Expert Report

Estimate in Respect of INTC No. 429

MUDFA programme Revision 8

The Edinburgh Tram Project

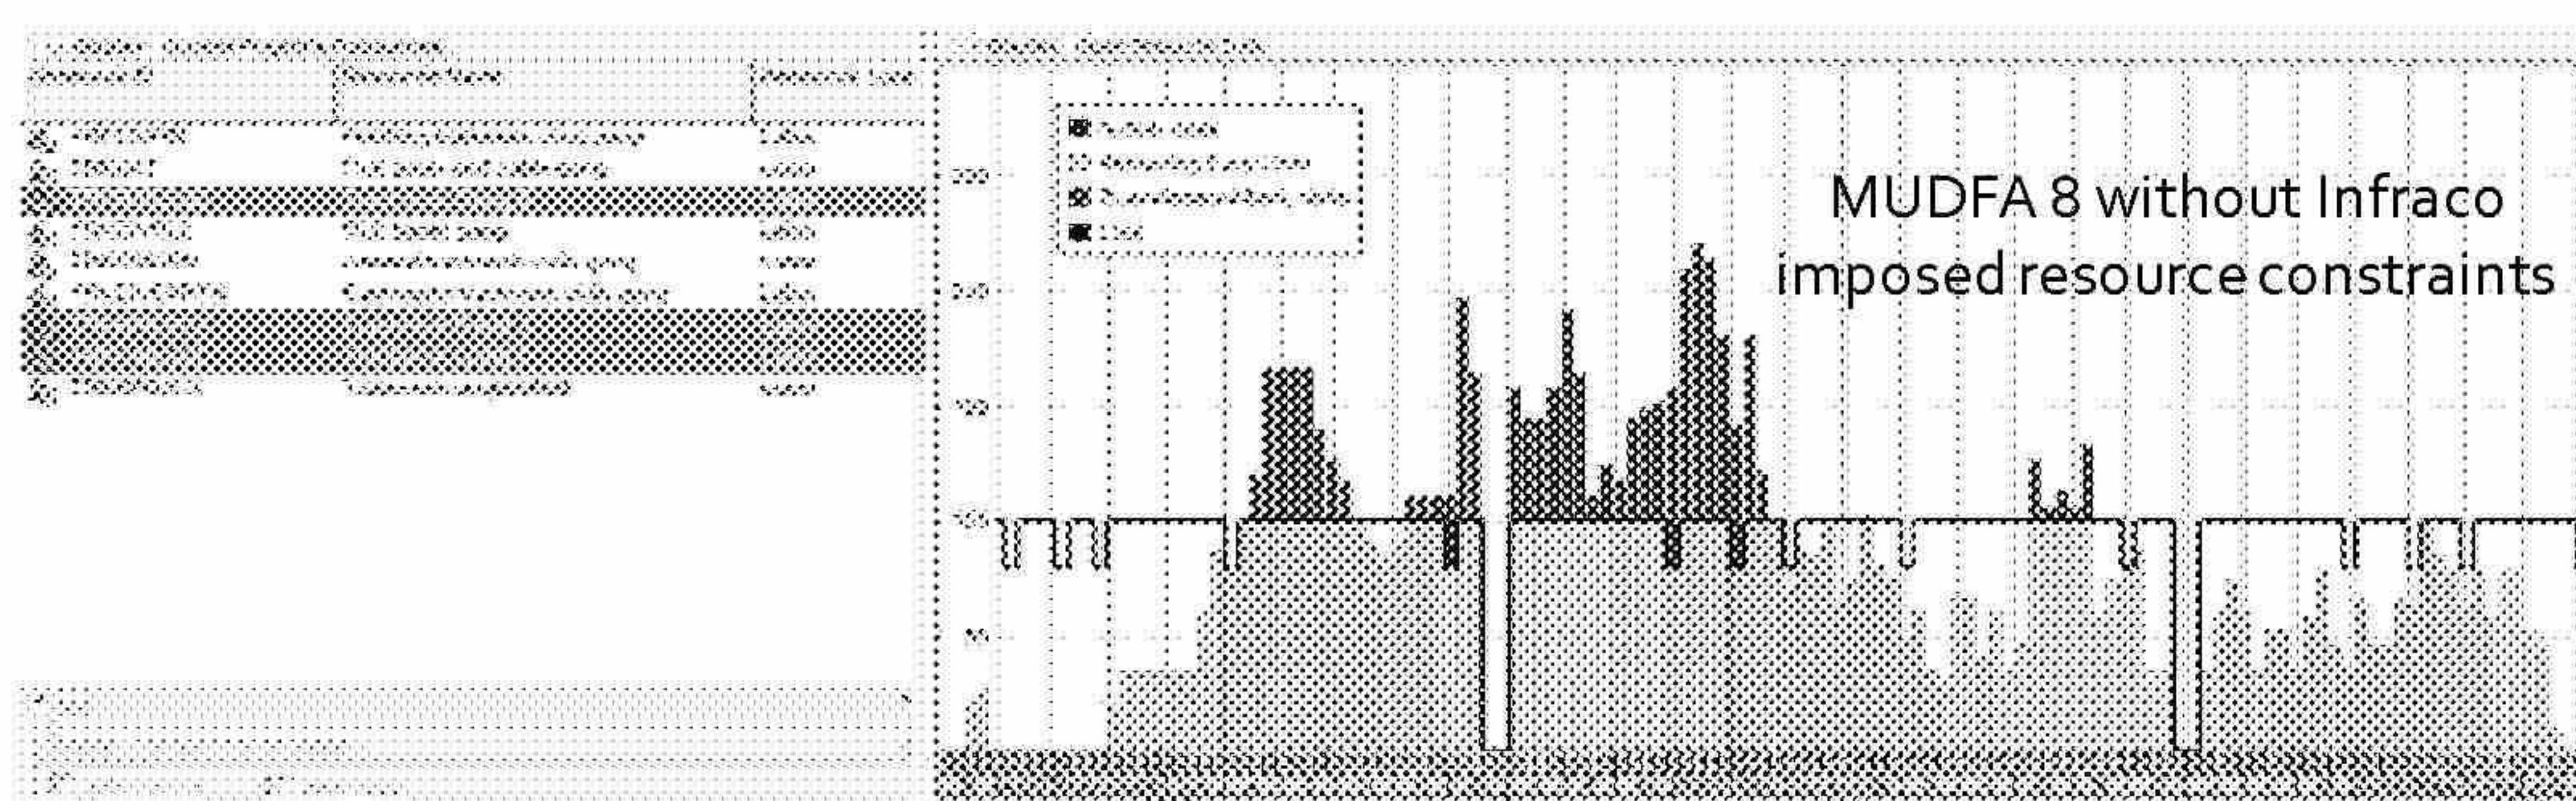
- i) Below is the track gang resource demand profile from the Infraco's "mitigated" delay analysis programme (i.e. Appendix D of the Estimate). It, generally, although not strictly, adheres to the Infraco's stated resource constraint of three track laying gangs.
